Pentium® II Processor Specification Update

Release Date: September 1998

Order Number: 243337-018

The Pentium® II processor may contain design defects or errors known as errata which may cause the product to deviate from published specifications. Current characterized errata are documented in this Specification Update.

Figure 1. UP Dual Ended Termination (DET)

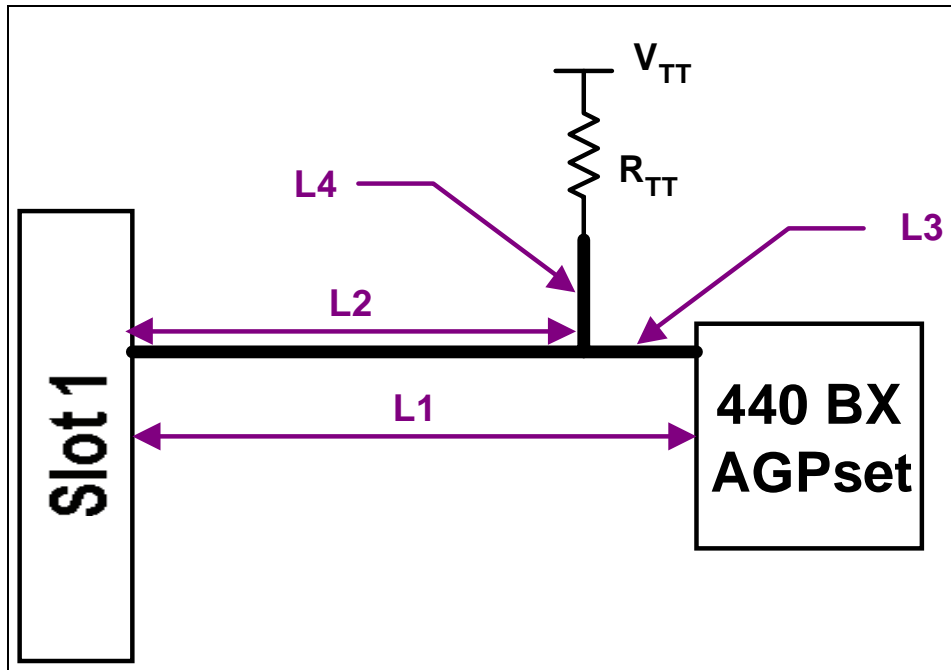
For UP-DET topologies (see Figure 1), the trace length $L1$ must be between 1.5" to 4.5" while using a 56 Ω termination resistor.

Figure 2. DP Dual Ended Termination (DET)

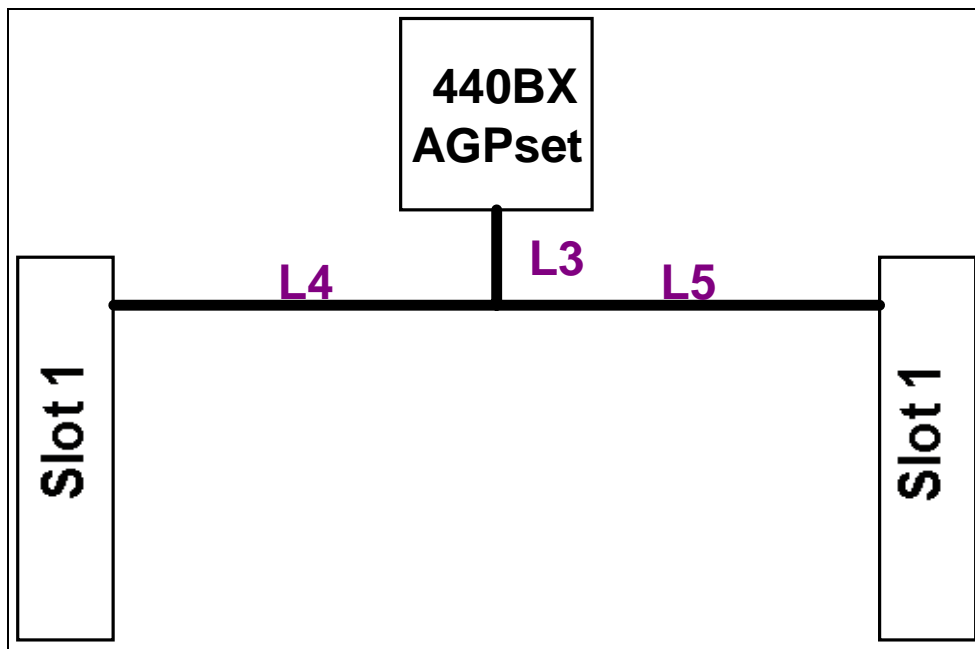
For DP topologies (see Figure 2) installed with a processor and a termination card, $L4 + L3$ or $L5 + L3$ must be less than or equal to 4.5". Additionally, for DP platforms with one processor installed, the termination card should be placed in the longer leg.

Figure 23. Processor with an Example Low Profile Heatsink Attached Using Spring Clips

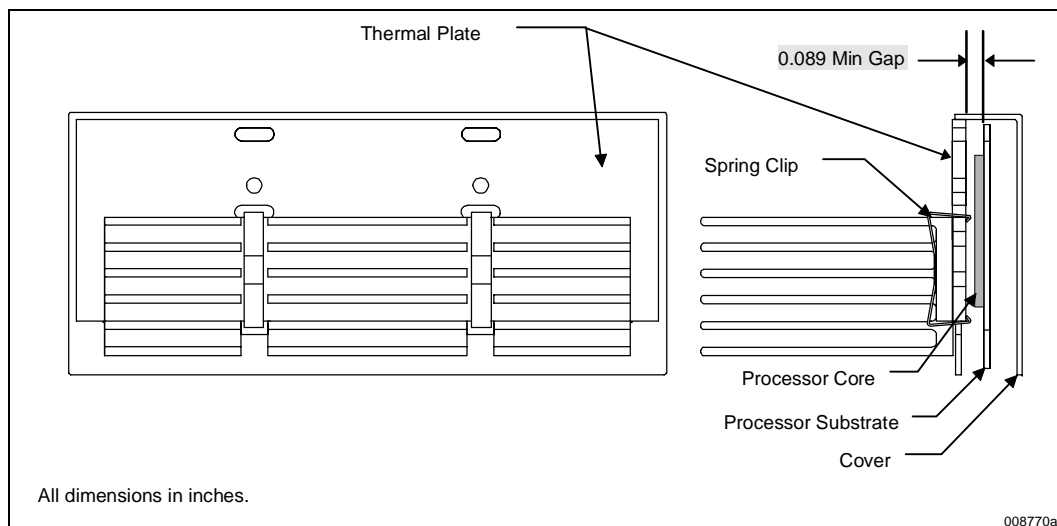
Figure 23 and Figure 24 illustrate example clip designs to support a low profile and a full height heatsink, respectively. The clips attach the heatsink by engaging with the underside of the thermal plate. The clearance of the thermal plate to the internal processor substrate is a minimum **0.089"** (illustrated in Figure 23 and Figure 24). The clips should be designed such that they will engage within this space, and also not damage the substrate upon insertion or removal. Finally, the clips should be able to retain the heatsink onto the thermal plate through a system level mechanical shock and vibration test. The clips should also apply a high enough force to spread the interface material for the spot size selected.

Figure 26. Heatsink Rivscrew* and Thermal Plate Recommendations and Guidelines

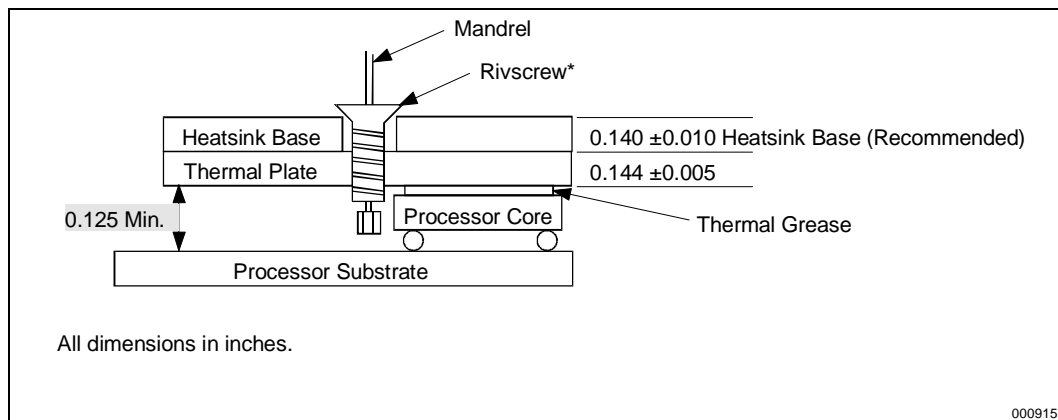
The Rivscrew attach mechanism uses a specialized rivet that is inserted through a hole in the heatsink into the thermal plate. Upon insertion, a threaded fastener is formed that can be removed if necessary. For Rivscrew attachment, the minimum gap between the thermal plate and the processor substrate is **0.125"**. For use of the Advell Rivscrew (part number 1712-3510), the heatsink base thickness must be $0.140 \pm 0.010"$. See Figure 25, Figure 26 and Figure 27 for details of heatsink requirements for use with Rivscrews.

Figure 6. BCLK to Core Logic Offset

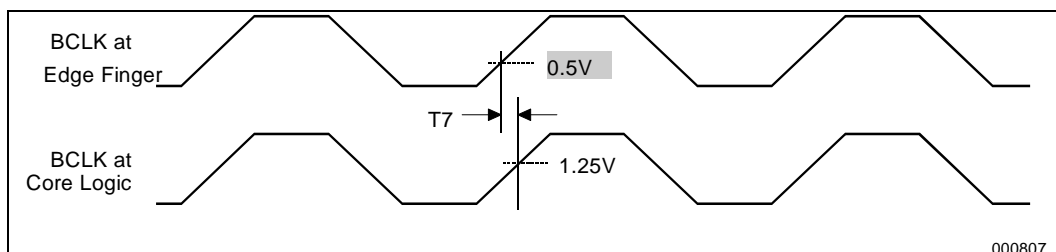
In Figure 6 of the *Pentium® II Processor at 233 MHz, 266 MHz, 300 MHz, and 333 MHz* datasheet, the following changes should be made:

Figure 7. BCLK*, PICCLK, and TCK Generic Clock Waveform

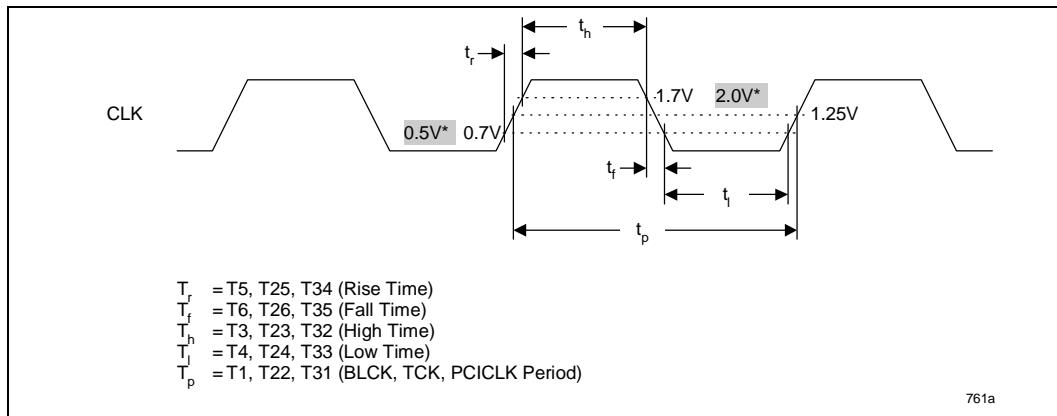
In Figure 7 of the *Pentium® II Processor at 233 MHz, 266 MHz, 300 MHz, and 333 MHz* datasheet, the following changes should be made:
